RE: CENTRE OF CIVILIZATIONS, CULTURES AND CITIES - 78-90 QUEENS PARK HIA ADDENDUM

This letter is an Addendum to the Heritage Impact Assessment ("2020 HIA") that ERA previously prepared, dated March 18, 2020. The 2020 HIA discusses the proposed development in the context of the site's identified heritage elements as well as the adjacent heritage resources. The 2020 HIA finds the proposed development will help meet the University of Toronto's demand for new institutional space and provide a mix of functions including classroom, administration, musical performance, and communal space. The CCC building will help to create a new gateway to the campus from the north and provide for the renewal of an important heritage resource.

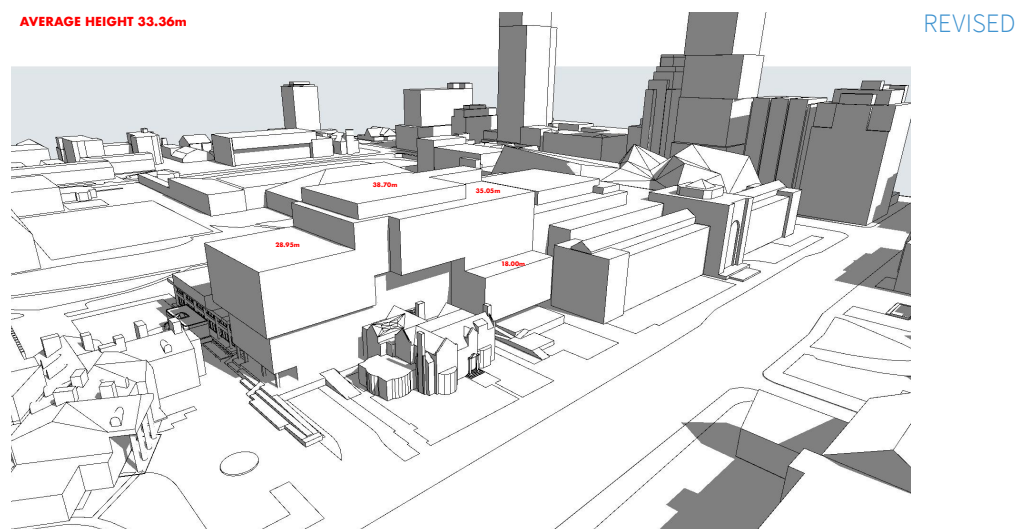
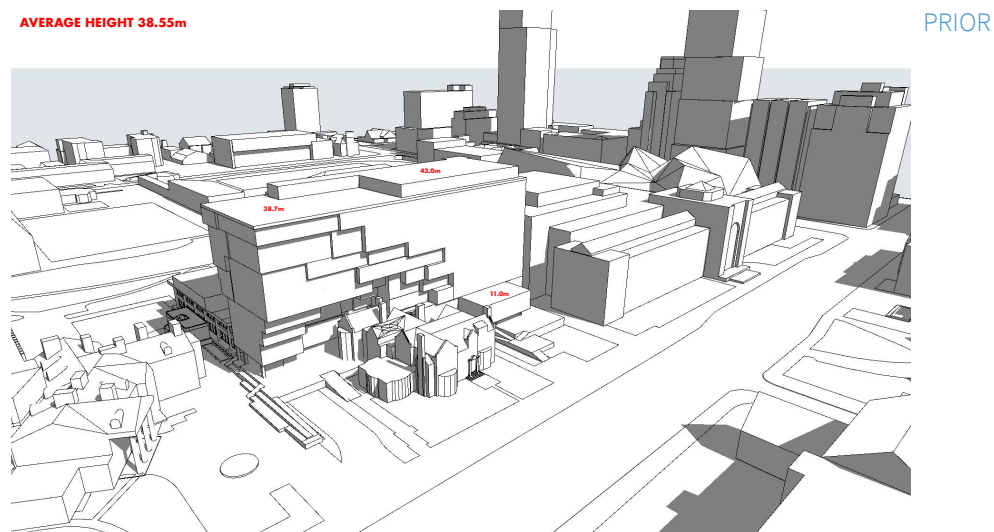
The proposal has been revised to provide for a zoning envelope for the proposed development, which includes the following changes:

- 1. Reduced Building Height; and**
- 2. Revised Massing with Modifications to Falconer Hall.**

The building height has been revised to concentrate the tallest portion of the building to the north of the site with a height of 35.05m and mechanical penthouse above, and the building steps down in height towards the south to a height of 28.95m. The building element fronting the plaza has been extended to the north and increased in height to 18m. The revised proposal will expand the one storey ground floor volume to enclose the below ground exit stair, slightly expand the ground floor lobby, and provide for the accessibility ramp into Falconer Hall. The visibility of the heritage facades in this area will remain generally consistent with the prior proposal. The views below are annotated with building heights.

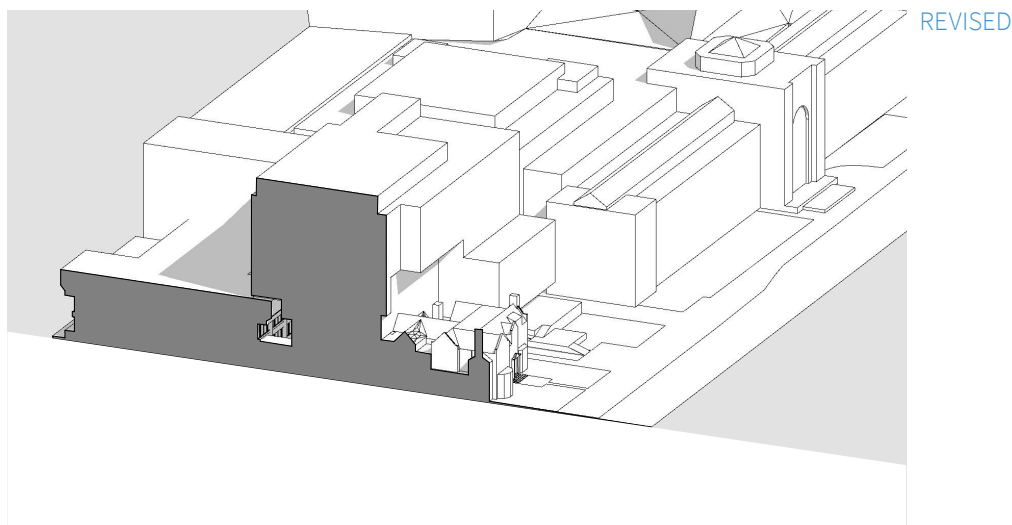
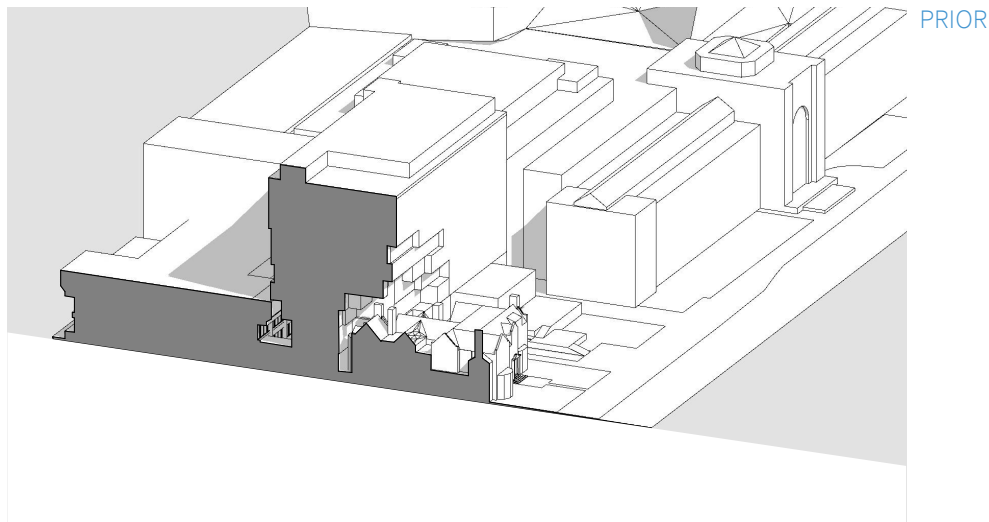
In the prior proposal, the building is substantially setback from the east elevation of Falconer Hall and as it rises the building cantilevers over Falconer Hall to the east. In the prior proposal the depth of the cantilever at its deepest point over Falconer Hall is 10.7 m. To the north of Falconer Hall the one storey element is setback 27.5 m from the east and 8.2m from the north property lines respectively, and the floors above stepback a further 7.5m.

In the revised proposal, the 1908 west addition is removed to accommodate the required building program to fit into a reduced building height and to regularize the CCC building footprint. The substantial setback of the CCC building from the east elevation of Falconer Hall is generally maintained and the depth of the cantilever over Falconer Hall at its deepest point has been reduced to 5.2 m and a new cantilever to the west averages 3m. To the north of Falconer Hall the building element fronting the plaza is setback 27.5m from the east and 0m from the north property lines respectively, and the floors above stepback a further 7.5m. See diagrams showing changes below.

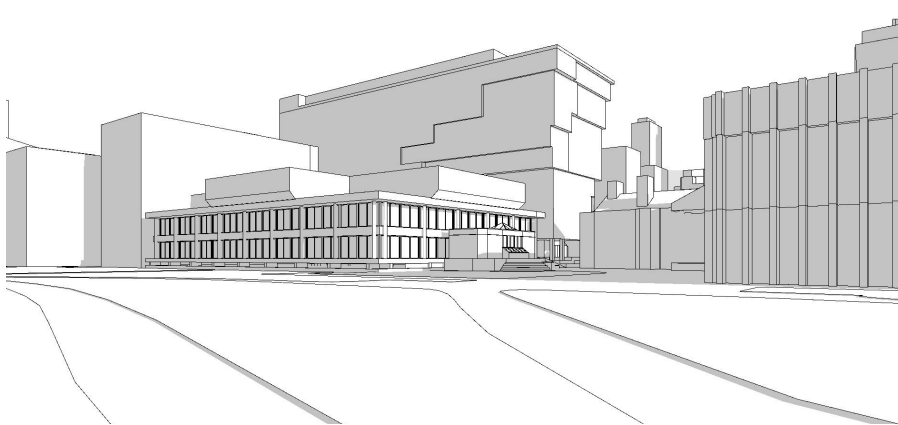
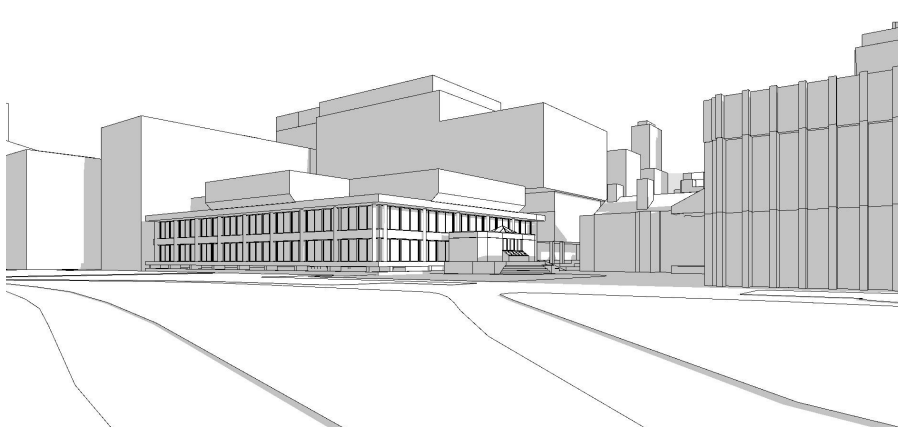
The revised proposal responds to the surrounding context with a massing that aligns the CCC building with horizontal and vertical datums from the adjacent heritage resources. Namely, the north building element fronting the proposed plaza matches the parapet height of the ROM's south elevation, the base of the south building face generally aligns with the south elevation of the Edward Johnson Building, and the soffit of the cantilevered volume generally aligns with the roof ridge of Flavelle House to the south. The modest cantilevers of the revised proposal echo the cantilevers of the Edward Johnson Building, and the stepped massing at the upper floors is akin to the step-up of the Edward Johnson Building flytower. The modest new cantilever over the Edward Johnson Building, created to accommodate the same building program on the shorter building, will maintain views of the east facade of the Edward Johnson Building consistent with the prior proposal.

Impact & Mitigation - Modifications to Falconer Hall

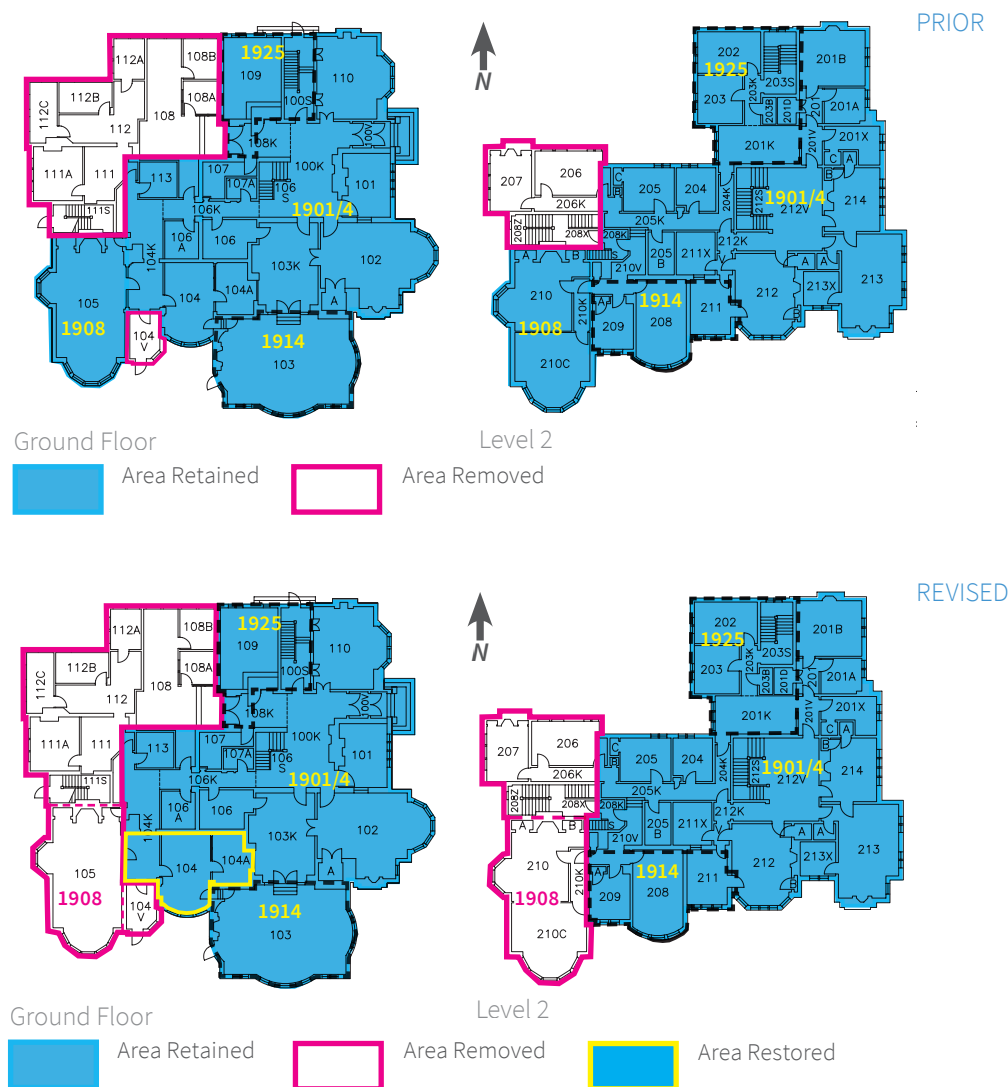
City Staff had provided considerable input on the prior proposal that resulted in the retention of the 1908 rear addition beyond what was originally contemplated for the site. As described in the considered alternatives section of the 2020 HIA once an expanded retention footprint for Falconer Hall was established, the design team studied several scenarios for how to achieve an appropriate architectural relationship with the southwest corner of Falconer Hall.

In the revised proposal, the height reduction and redistribution of program area results in the removal of the 1908 rear addition to Falconer Hall designed by Sproatt & Rolph. Notwithstanding the removal of the rear extension, the retained portions of Falconer Hall will be able convey the site's evolution and association to the architects that designed their respective areas, including Sproatt & Rolph (1901/4), Carrere & Hastings with E.G. Bird (1914), and Molesworth, West, and Secord (1925). To mitigate this impact the former Palm Room at the ground floor level will be restored to its original appearance based on available archival evidence and materials uncovered on site (see next page).

Impact & Mitigation - Connection at Northwest Corner of Falconer Hall

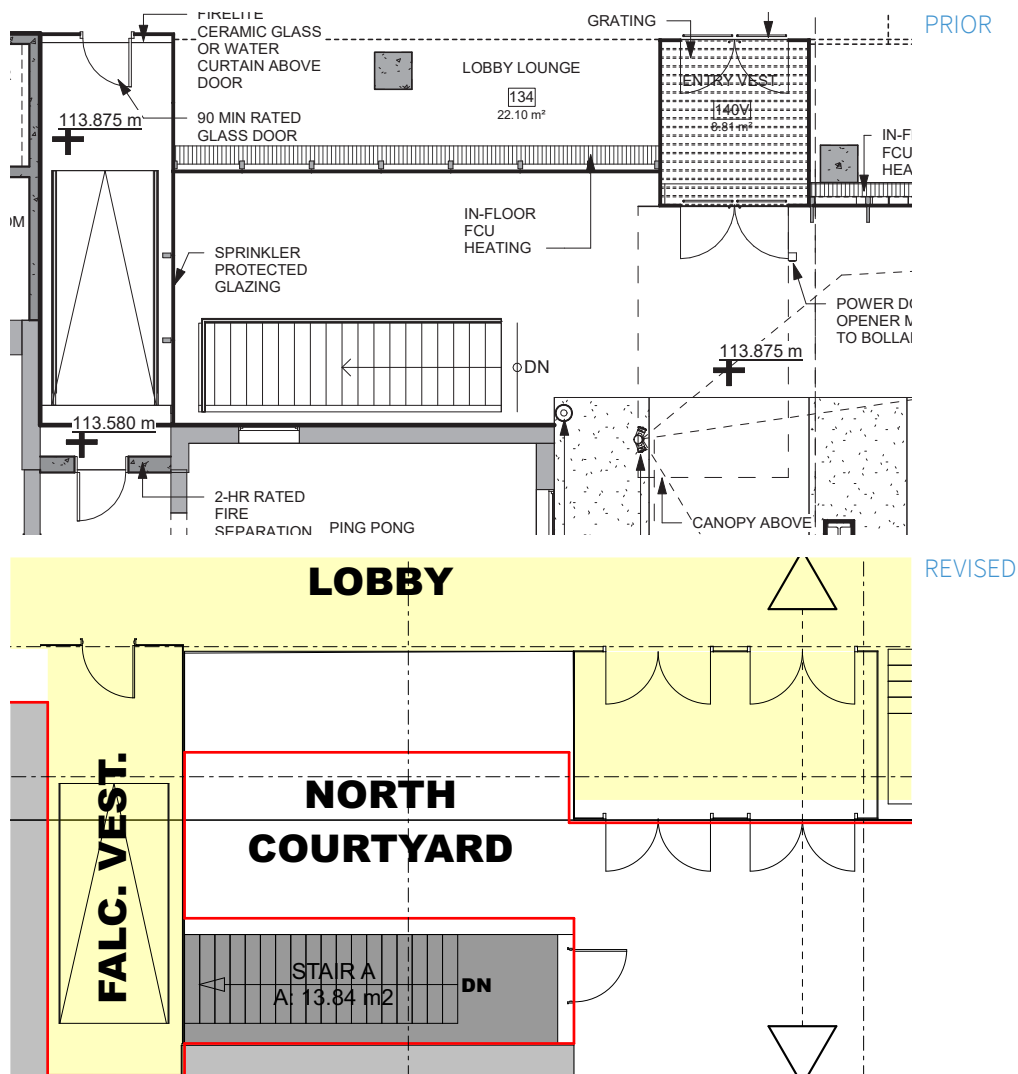
Repairs and conservation work will be carried out to newly re-exposed areas of Falconer Hall after demolition work is carried out. The existing condition of these areas cannot be fully determined until the removal work begins. The intent is to reinstate as closely as possible the original conditions and provide modifications if needed to ensure a compatible transition to the new CCC building. The slightly expanded one storey ground floor volume will provide weather protection for the exit stair and ramp while allowing for an open interior area next to the heritage building, and an additional entry door will enhance wayfinding.
